Halton District School Board

Addendum No. 4

RFT 26-030 Oakville #5 Elementary School & Child Care Facility

ADDENDUM NO. 4**Issued February 10, 2026**

QUIET ROOM CURTAIN WALLS - 231, 229, 331, 329

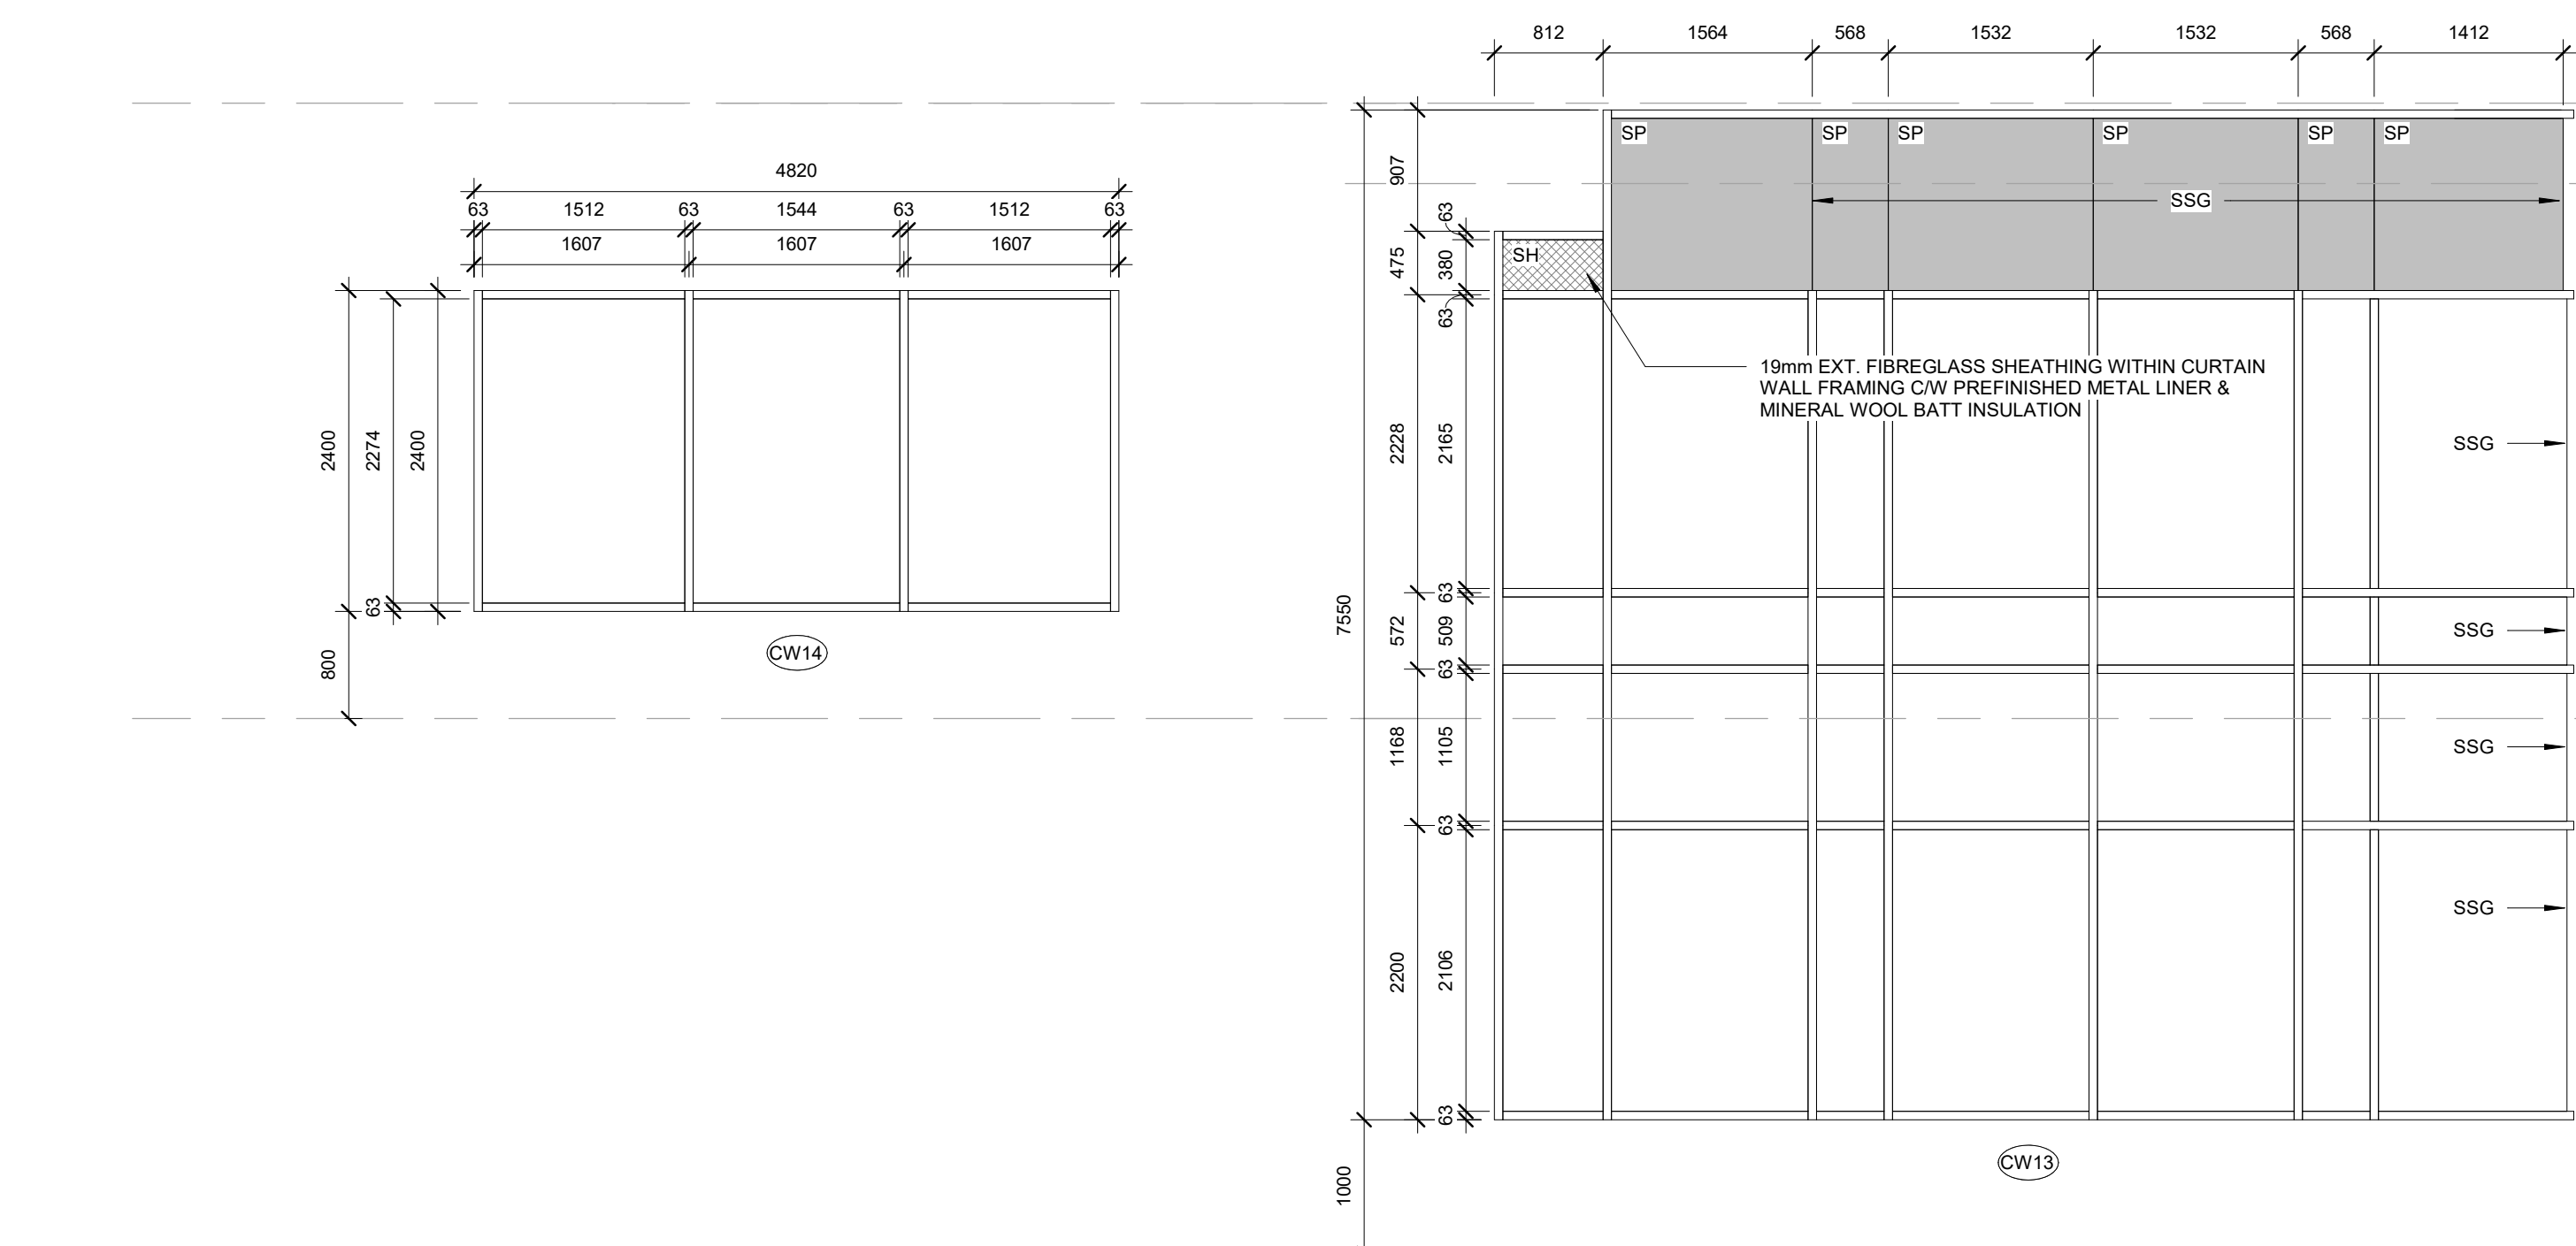
- .1 REVISE: QUIET ROOM 229, 231, 240, 245, 248, 329 and 331 wall finish to read: "BB / POR.WD".
- .2 REVISE: 'QUIET ROOM 229, 231, 240, 245, 248, 329 and 331 remarks to read: "REFER TO CURTAIN WALL SCHEDULE. BB ON ENTIRE WALL REFER TO ARCH. PLANS."
- .3 DELETE references to 'smoke baffles' in '157 Stair A' and '201 Stair A'.

VESTIBULE 101 - ELEVATION

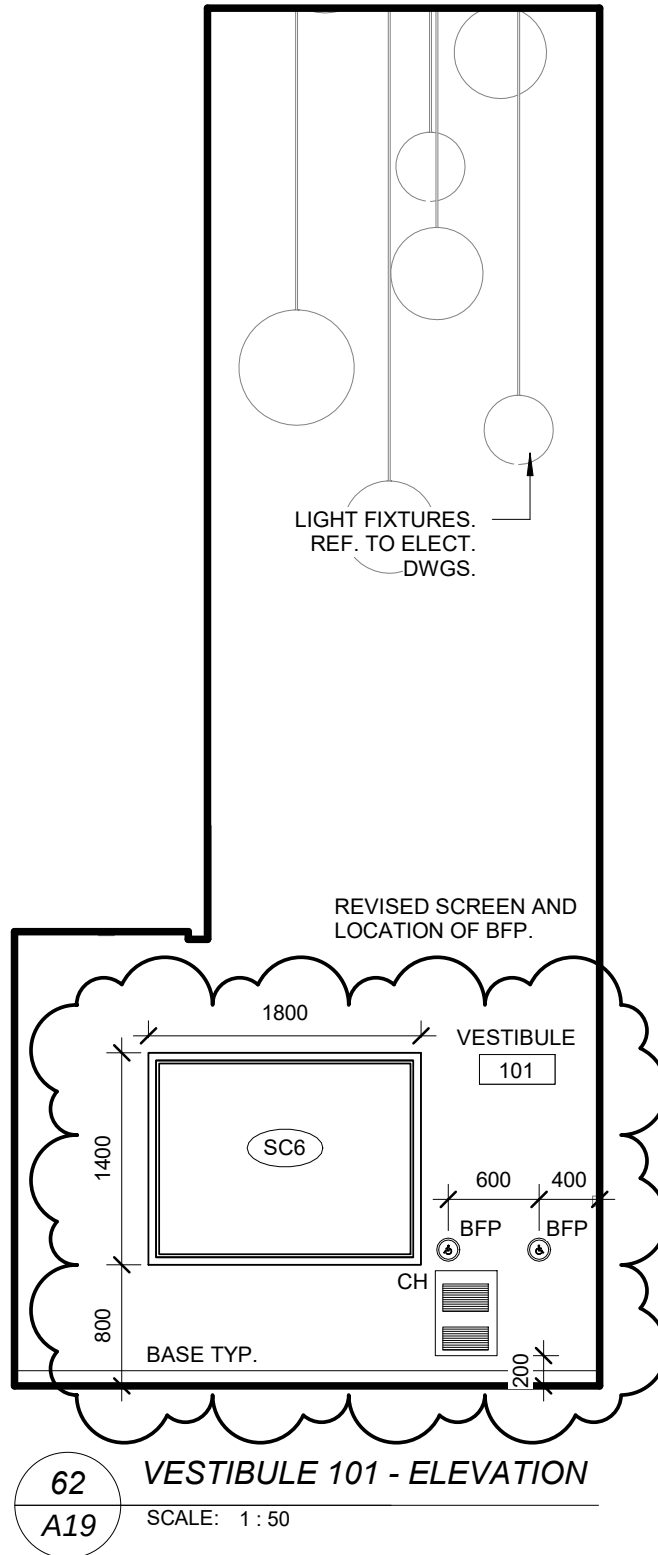
- .1 DELETE: screen tag 'SC2' next to Door 103 on interior elevation 1/A19.
- .2 REPLACE: screen tag 'SC2' with 'SC6' on interior elevation 1/A19.
- .3 ADD: elevation drawing 62/A19 'VESTIBULE 101 – ELEVATION', per enclosed SKA-4 for revised location of 'BFP' in VESTIBULE 101.

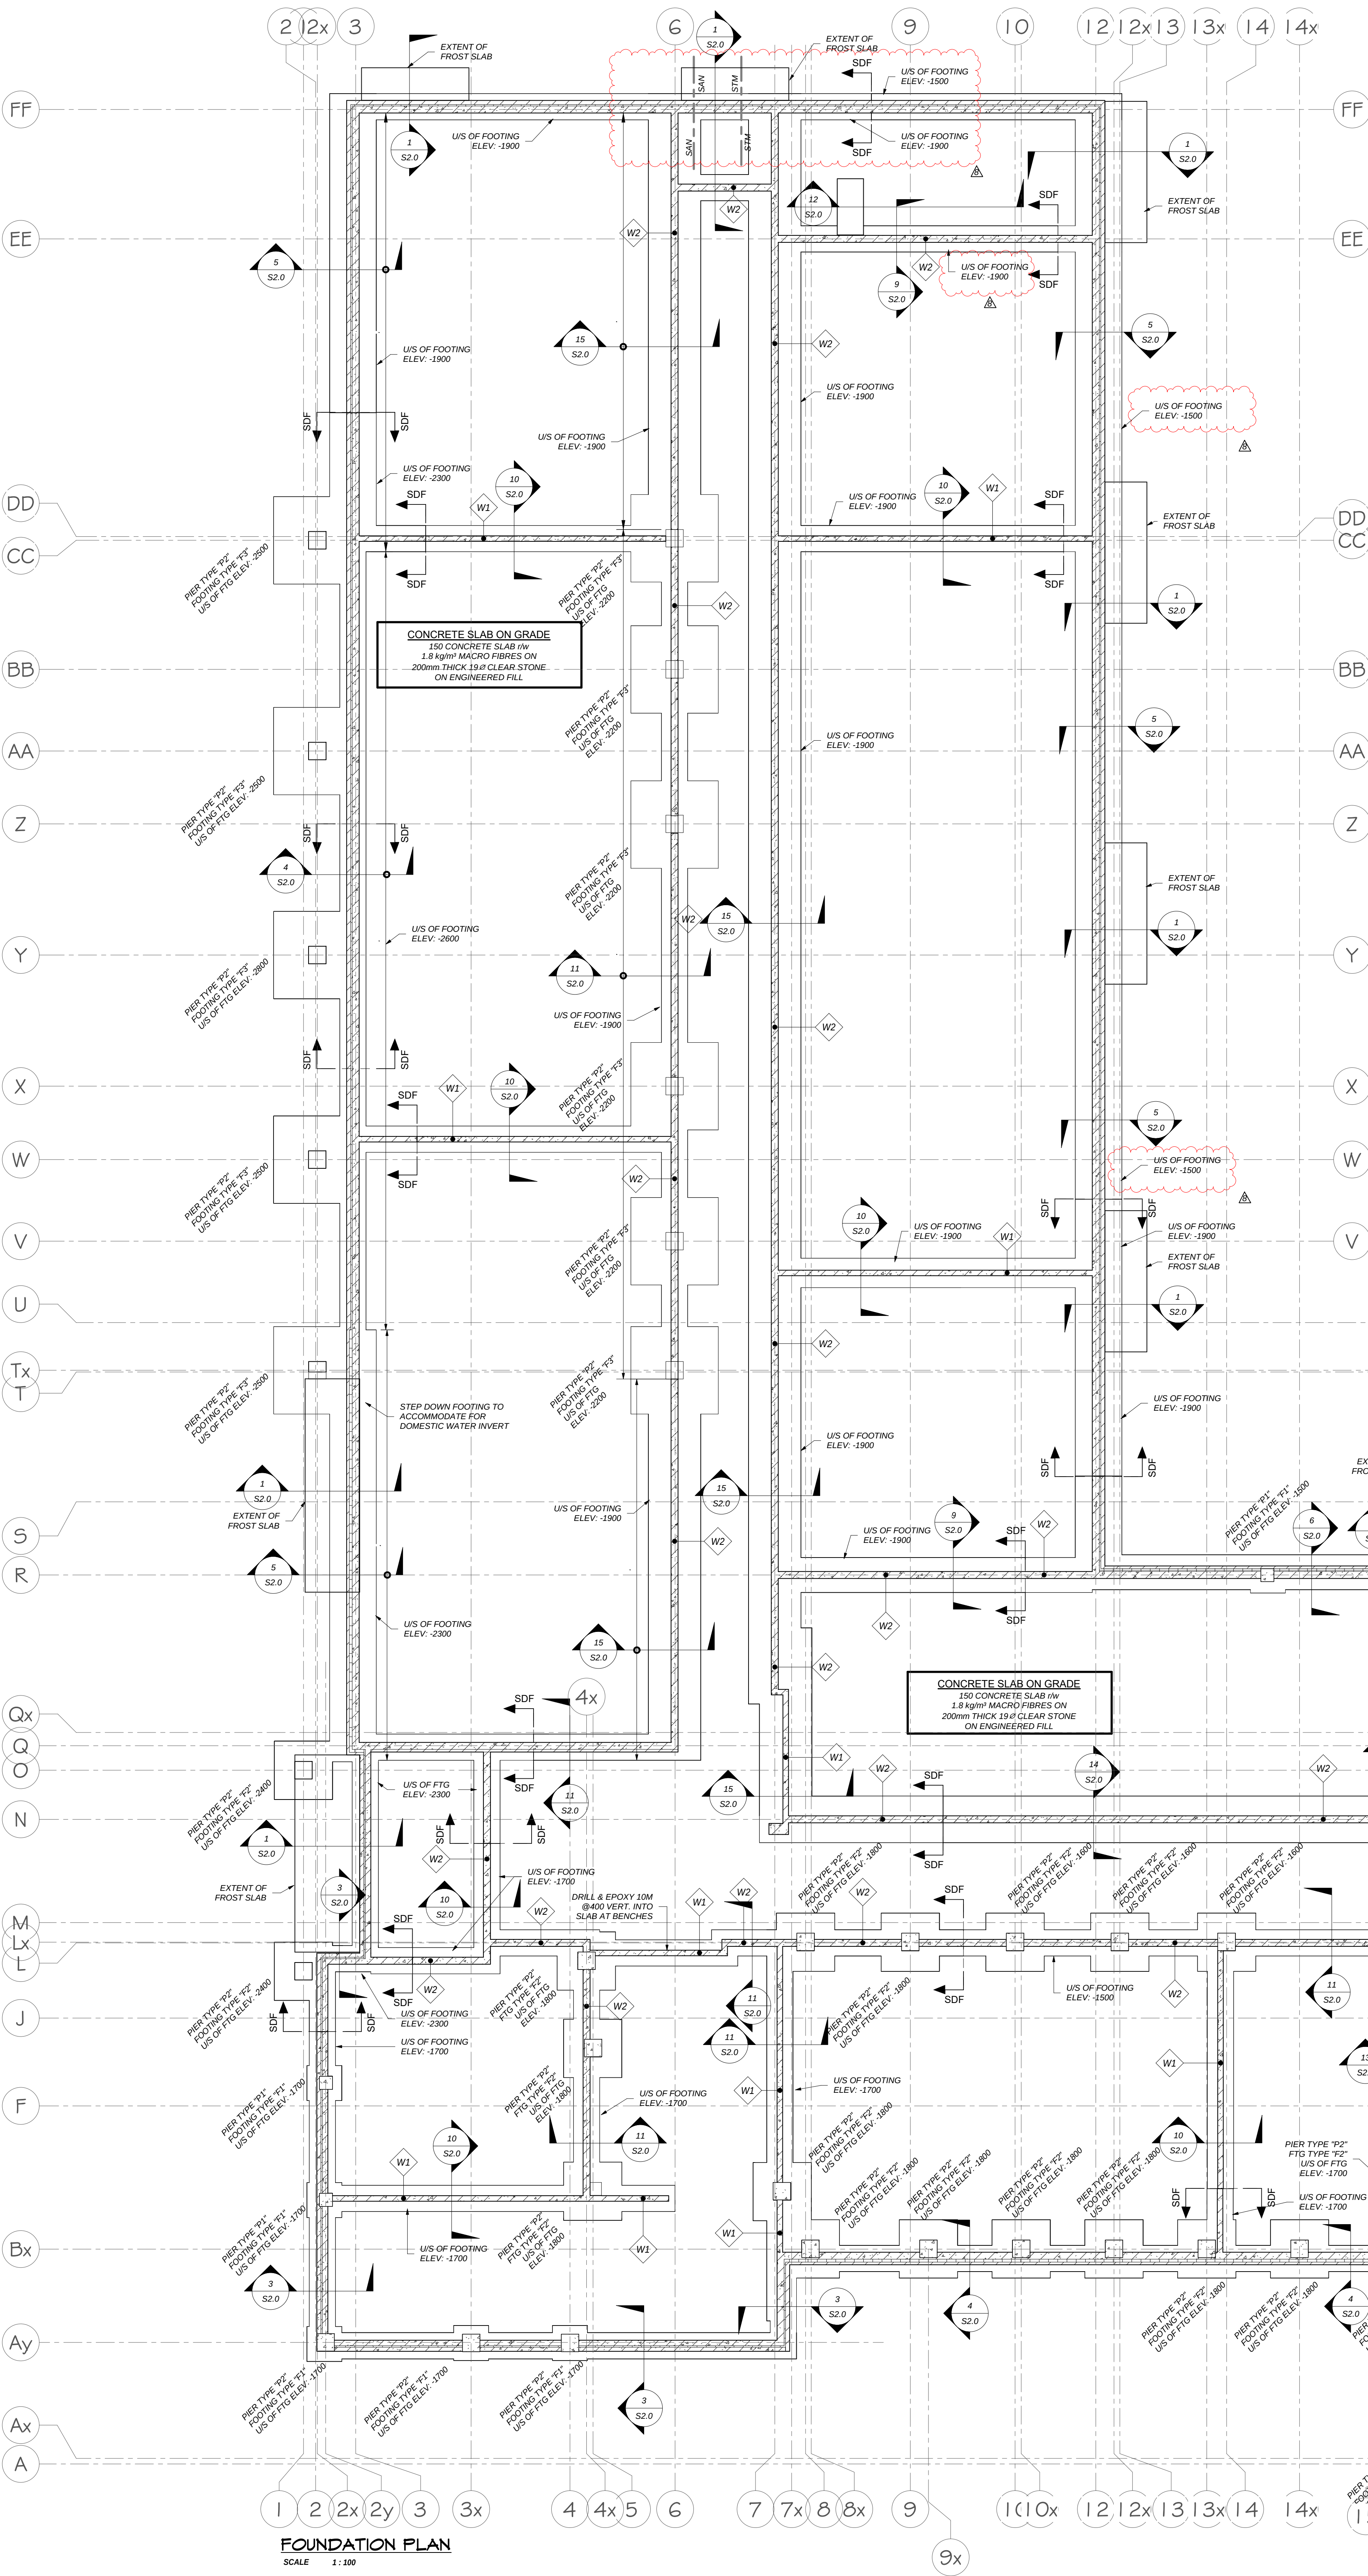
QUESTION 38: Drawing S1.0 – Please clarify the footing heights at gridline 6 & FF. Foundation steps are shown here, but no u/s of footing is noted.

Question 1: *Drawing S1.0 – Please clarify the footing heights at gridline 6 & FF. Foundation steps are shown here, but no u/s of footing is noted.*

ANSWER 38: Refer to revised drawing S1.0 attached.

Response 1: Refer to revised drawing S1.0 attached.
